**ADDENDUM # 4****Renovation of Commons A**

WBA 21-034.01

**TO: All Bidders****DATE: 30 January 2023**

**Renovation of Commons Building A**  
**BID SET**  
Tuskegee University  
Benjamin F. Payton Drive, Tuskegee, AL 36088  
21-034.01

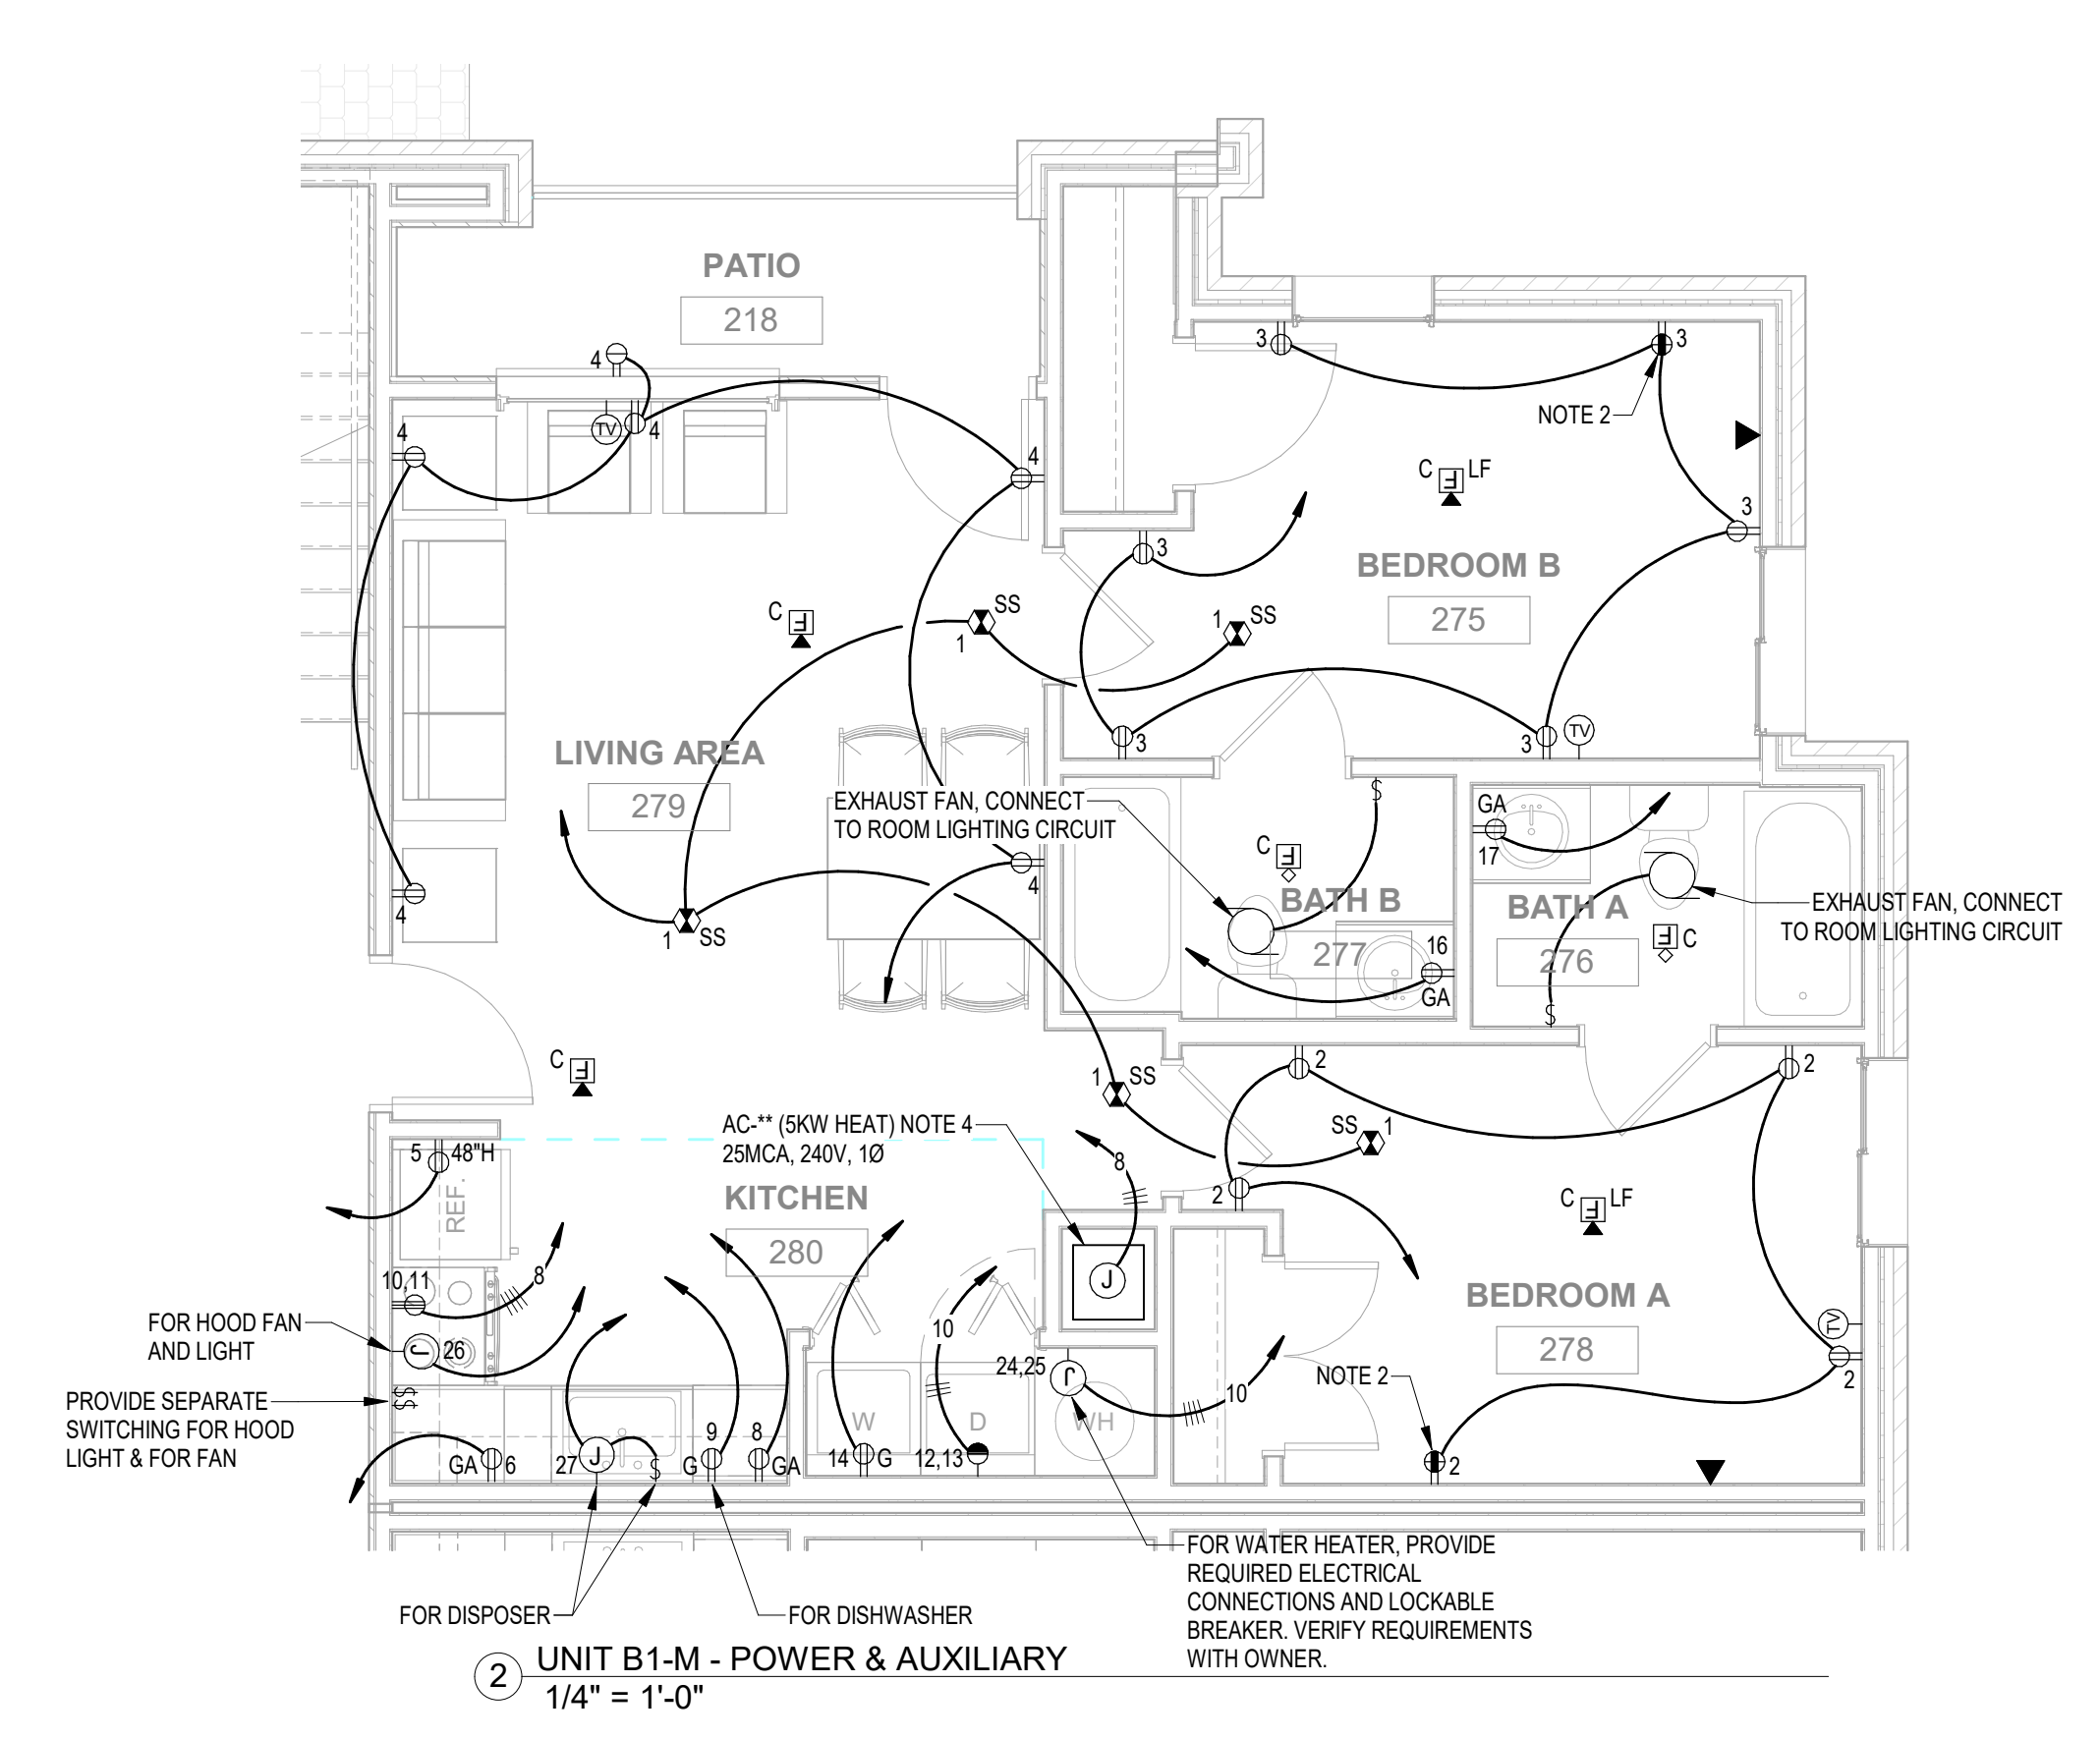
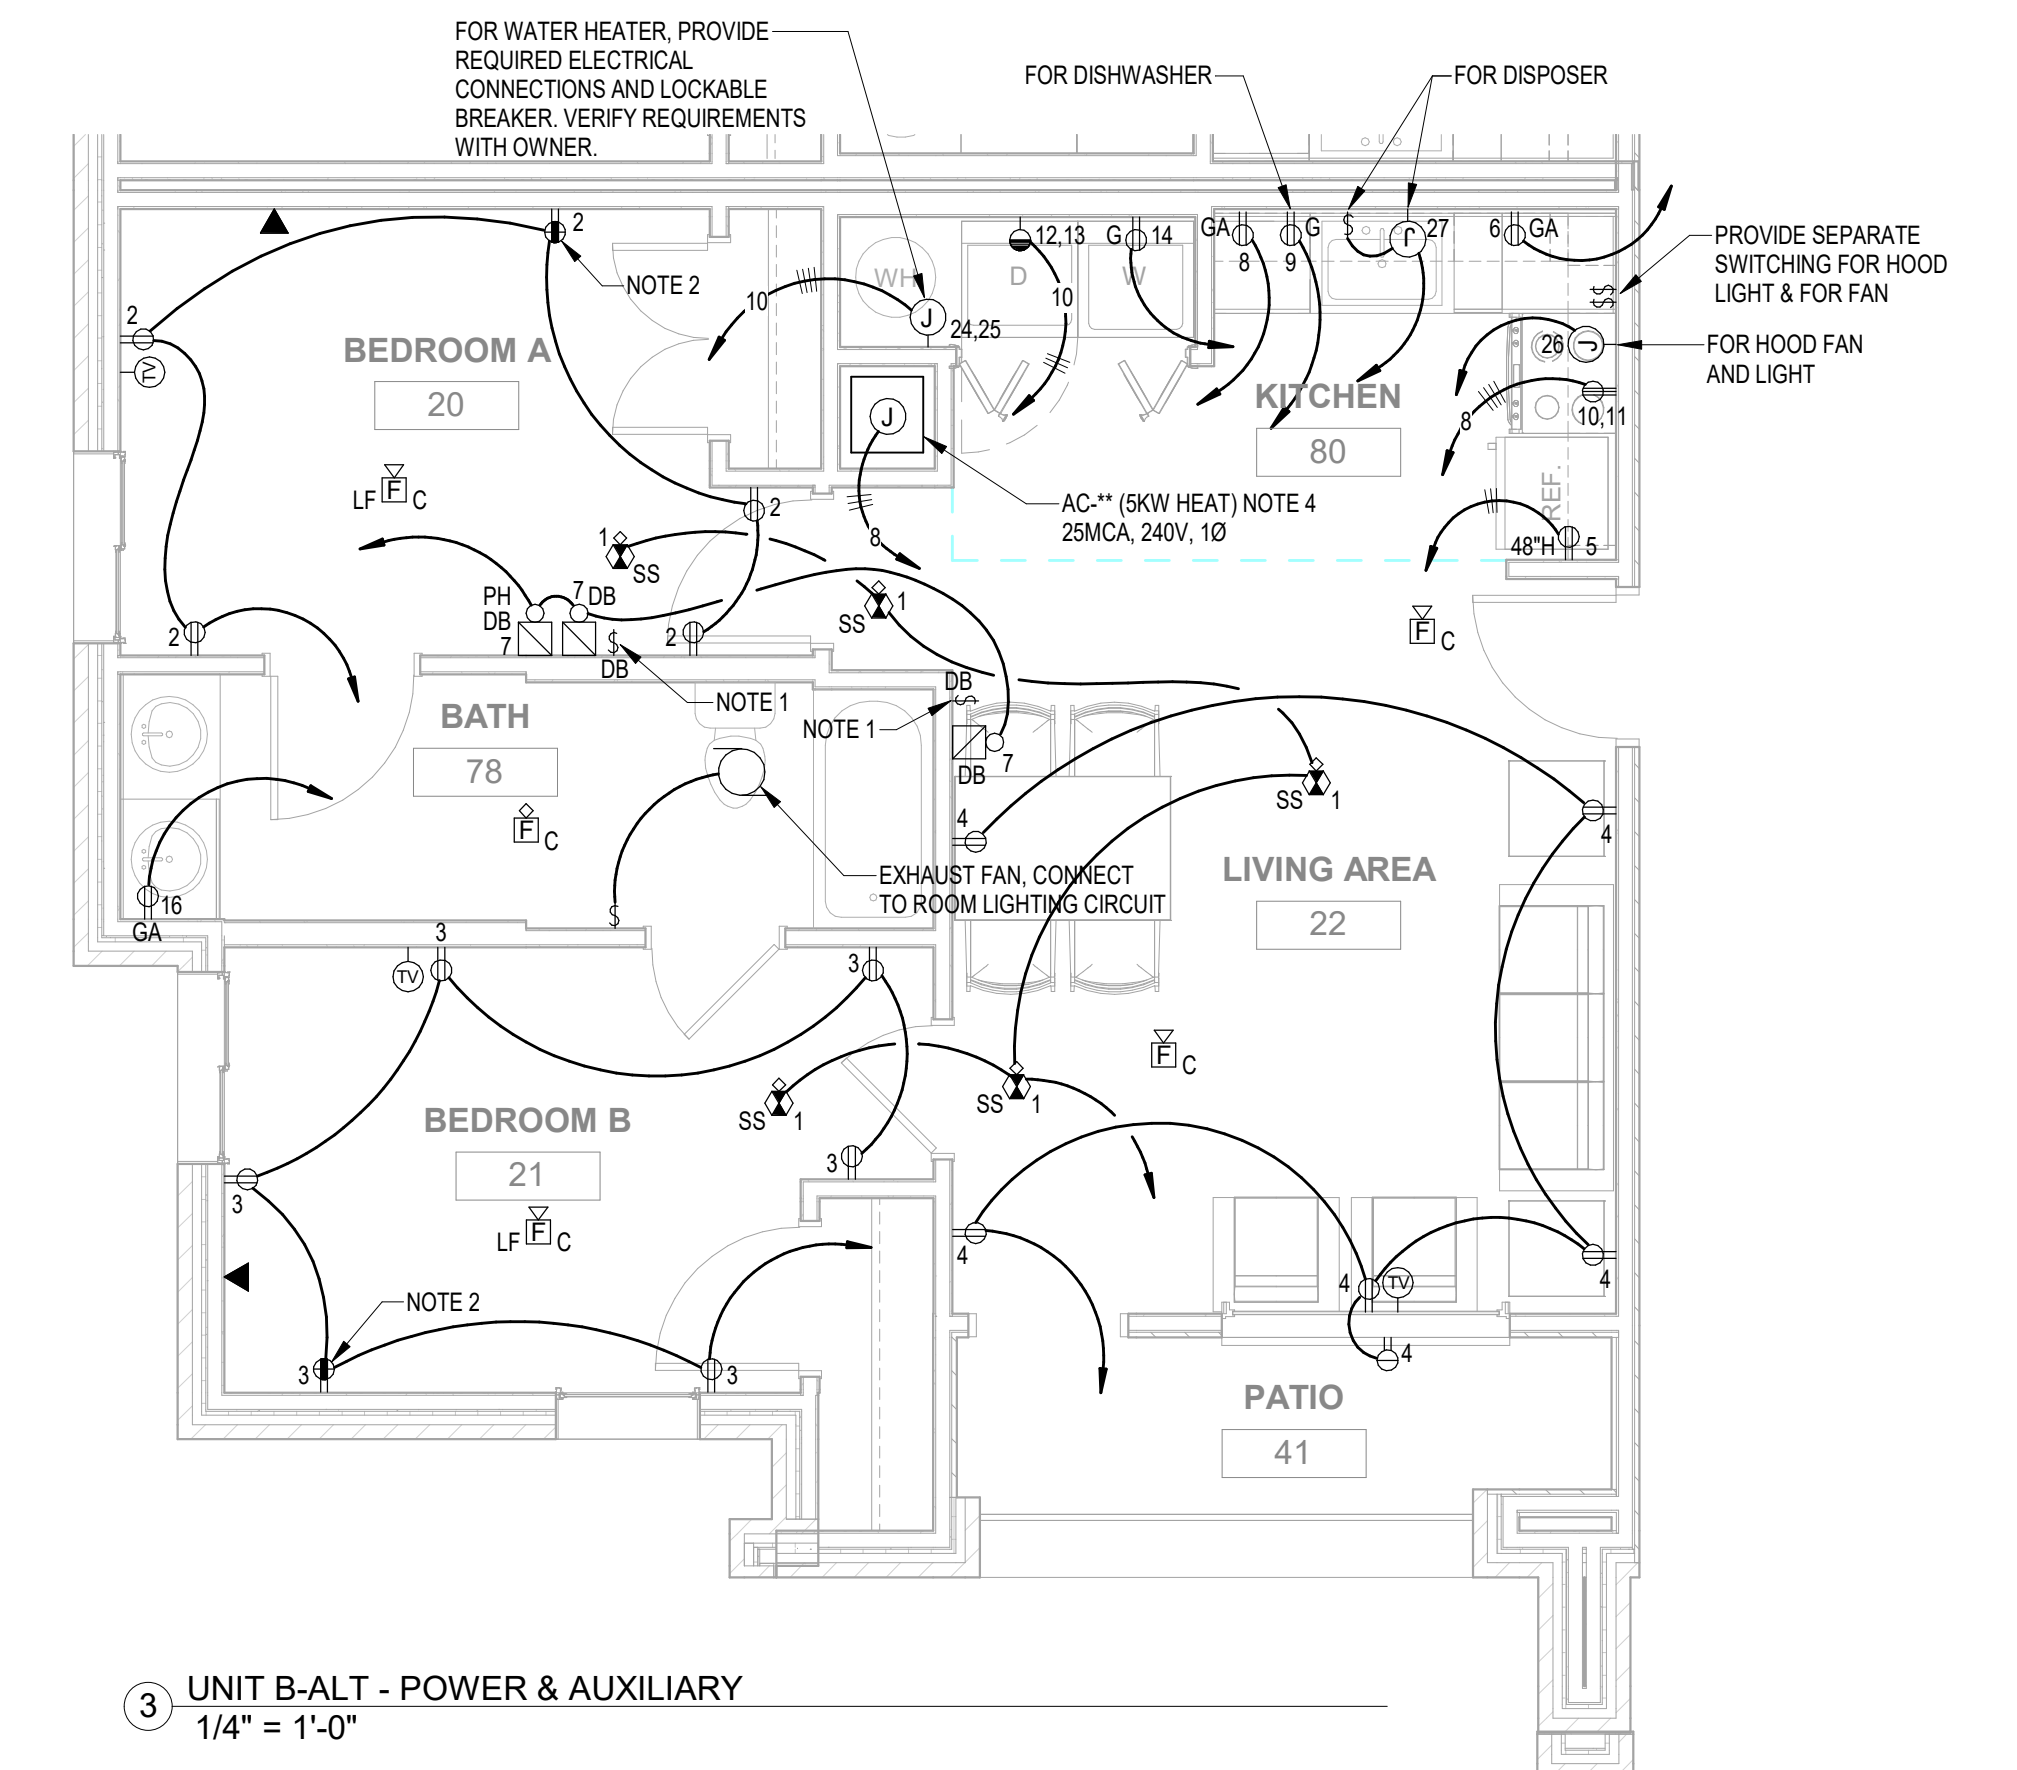
7. Sheet E5.2 – Revised device mounting heights to incorporate DCM review comments.
8. Sheets P001/P101/P102/P103 – North arrow and graphic scales were added, additionally riser diagram of the hot and cold water piping were added to incorporate DCM review comments.
